Town of Brunswick, Maine
STAFF REVIEW COMMITTEE

1. **Case #16-052, Little School House on Maine:** The Committee will review and take action on a **Final Plan Minor Development Review** application for the Little School House on Maine submitted by authorized representative, John Libby Construction to construct a 1,440 square foot building addition to an existing 3,218 square foot building, and add three (3) new parking spaces to an existing parking lot. The building that is the subject of the proposal will continue to be used for Educational Use as previously approved by the Planning Board under Special Permit standards. The proposed development is located at 368 Maine Street within the **R3 (Maquoit Road Neighborhood) Zoning District (Map 22, Lot 188).***
2. **Adjourn**

1. Project Name: The Little Schoolhouse on Maine Addition

Minor Development Review
REVIEW MEMORANDUM
Town of Brunswick
Department of Planning and Development

Site Plan for Proposed Addition
At
368 Maine Street
In
Brunswick, Maine
For
Baumgartner Real Estate Holdings, LLC.
C/O John Libby ~ 22 Cribstone View Rd. ~ Harpswell, ME 04079

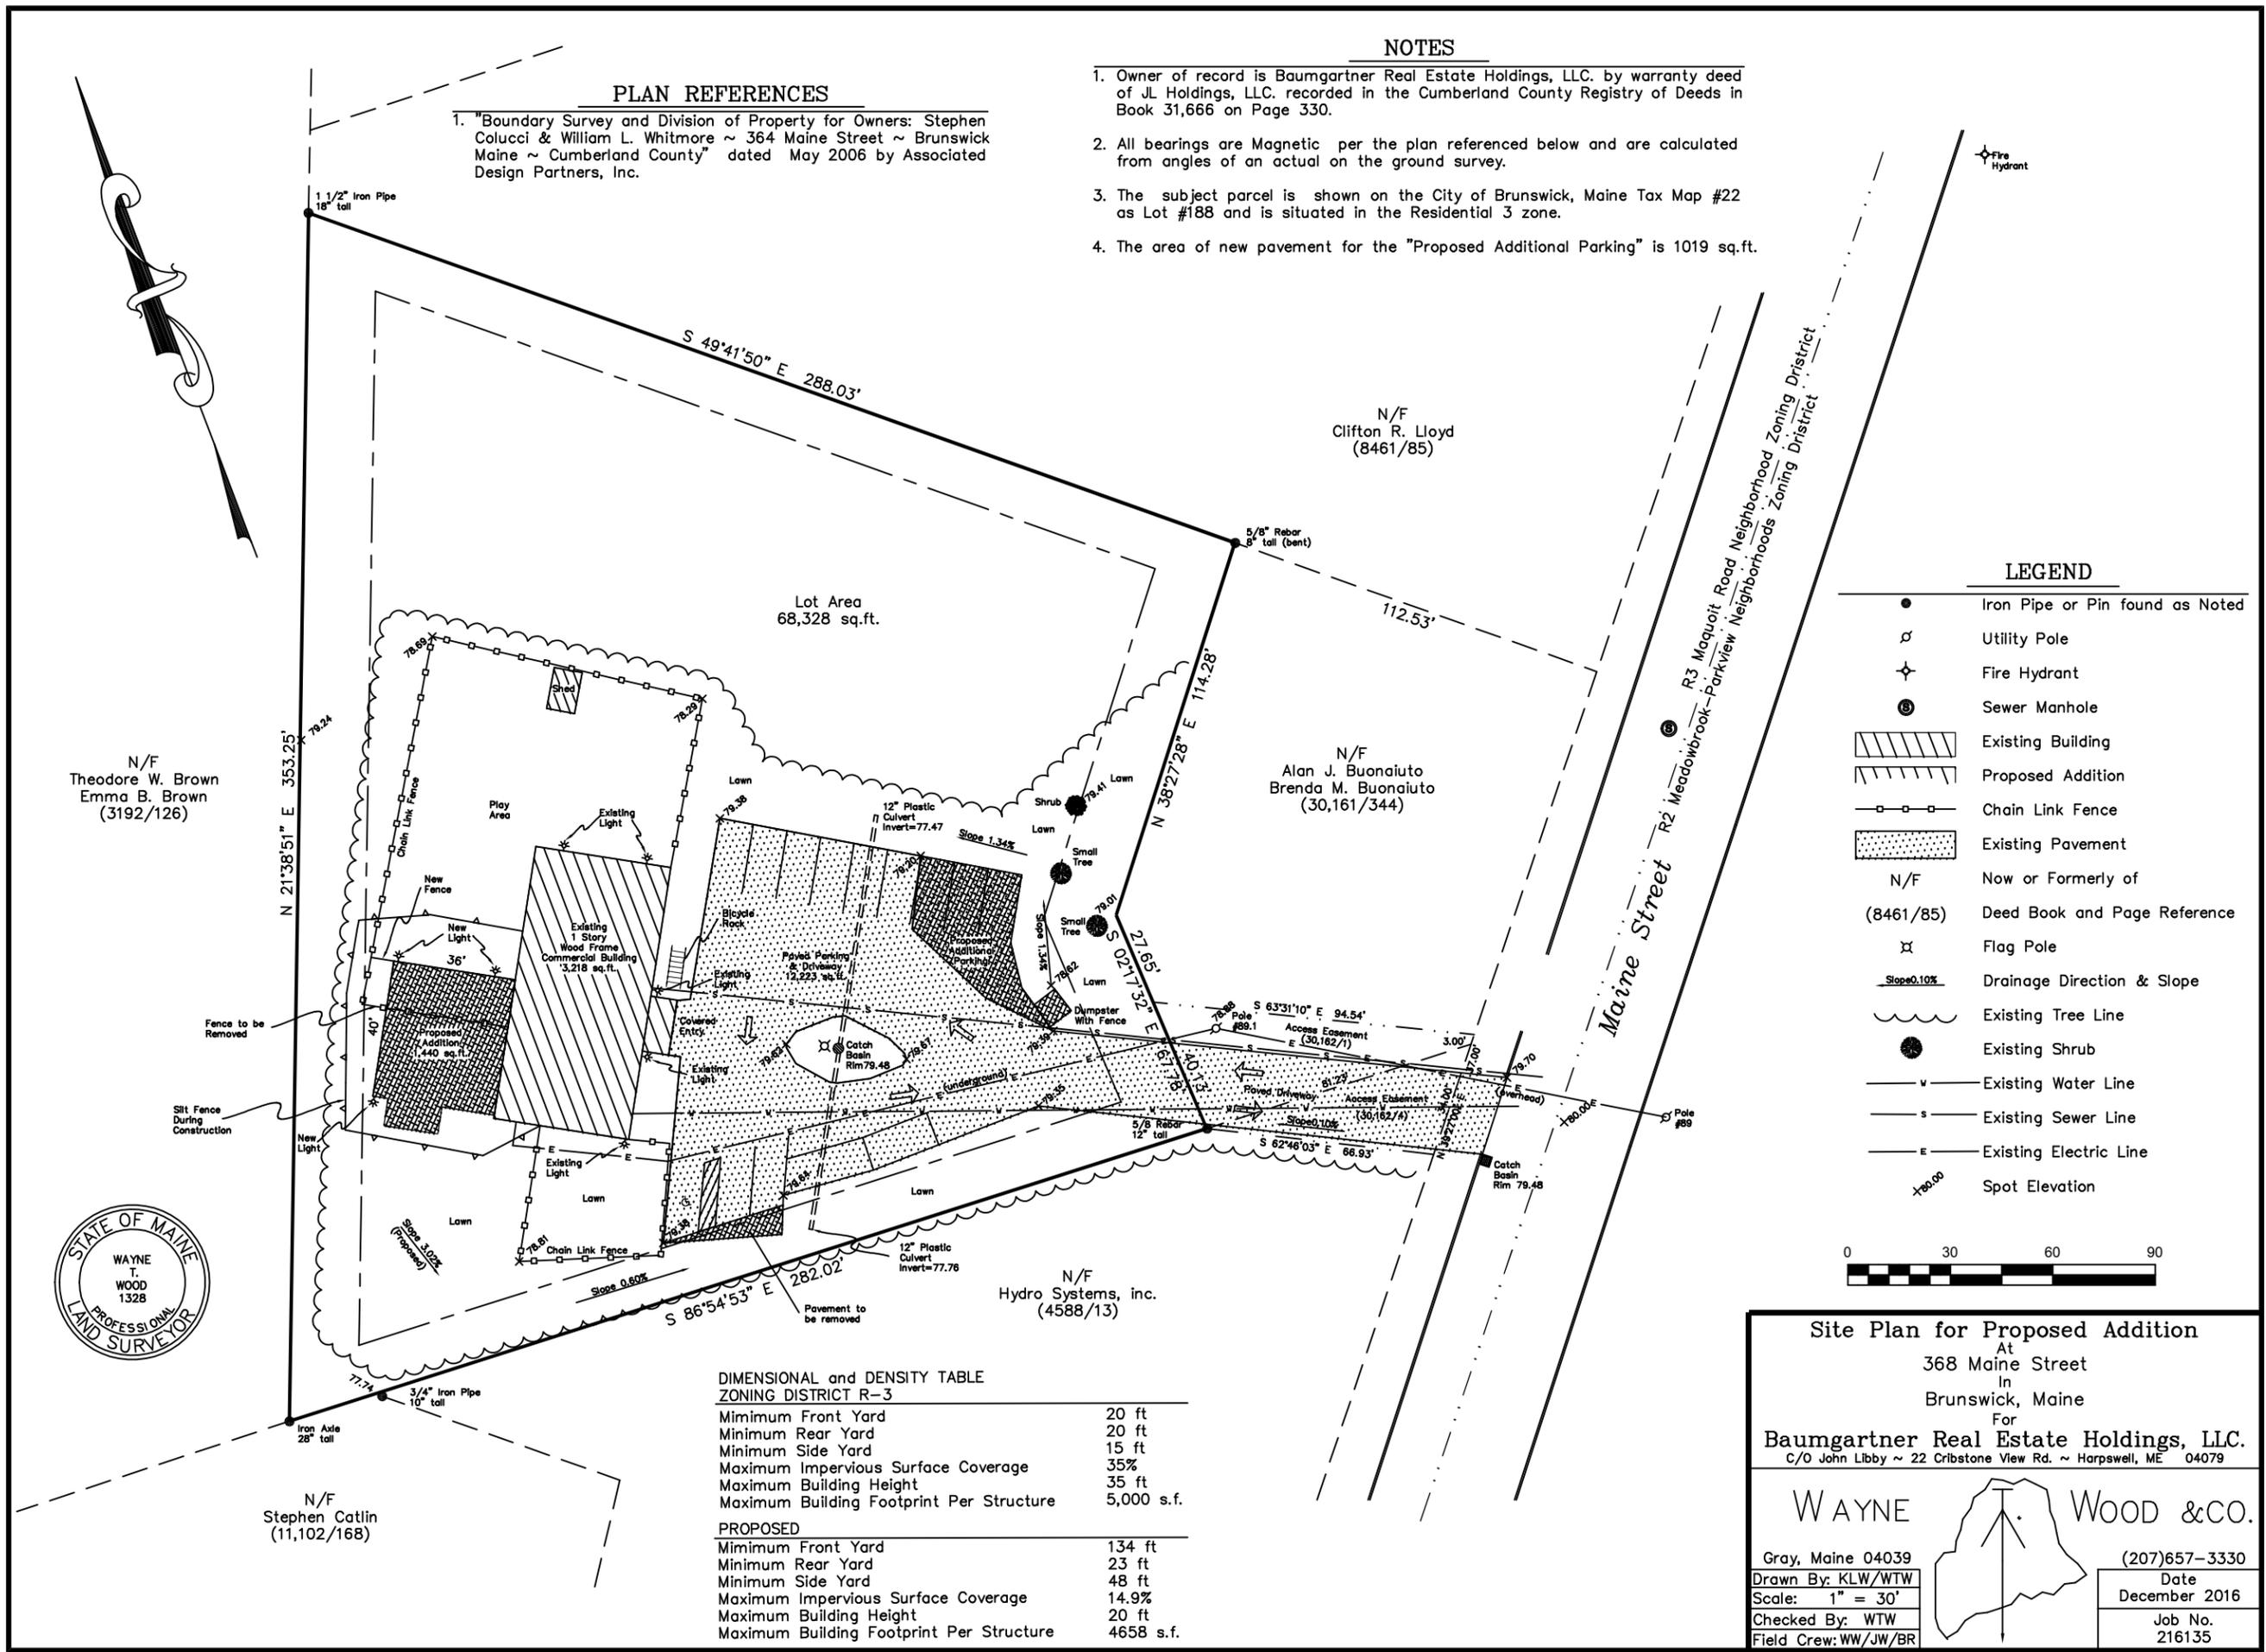
1. Submit a letter from the owner identifying you as the authorized representative;
2. Submit three (3) full size site plans printed to the indicated scale (1 inch = 30 feet)
Guidance: The building plans appear to be correctly scaled but the site plan is not to scale. Please review the plan and make sure it is printed to the intended scale.

7. Depict grading, and landscaping plans; indicating grade change, swales, vegetation to be preserved, and new vegetation used to stabilize areas of cut and fill and/or screening; the size, location, and type of vegetation.

Consider amending the plan to include a reinforcement edge of the parking with riprap to prevent further erosion to the stormwater swale, and maintain finished grade of the parking lot. Concrete curb stops in parking spots to prevent vehicles from overhanging the swale may be an alternative to consider.

The soil tracks adjacent to the parking area and driveway may be corrected in the short term with basic erosion control measure such as a thick layer of straw mulch. For permanent control, consider adding a landscaped area to the plan with erosion control mix (stump grindings) and a few tall shrubs (examples: *red osier dogwood, rhododendron, high bush blueberry, sweet gale, winterberry, or mountain laurel*) near areas that exhibit vehicle tracks as a deterrent to vehicles that tend to drive off paved surfaces.

Please update the site plan with labels for percent grade (example: 0-8% grade); and stormwater drainage direction with arrows at the following areas:

8. Recalculate the existing and proposed impervious area and amend the site plan accordingly.

Guidance: The numbers shown on the plan for parking and driveway pavement do not appear to be correct. The parking and driveway square footage shown on the plan should include the extent of the driveway where it starts at Maine Street and the area of the existing and new parking lot area.
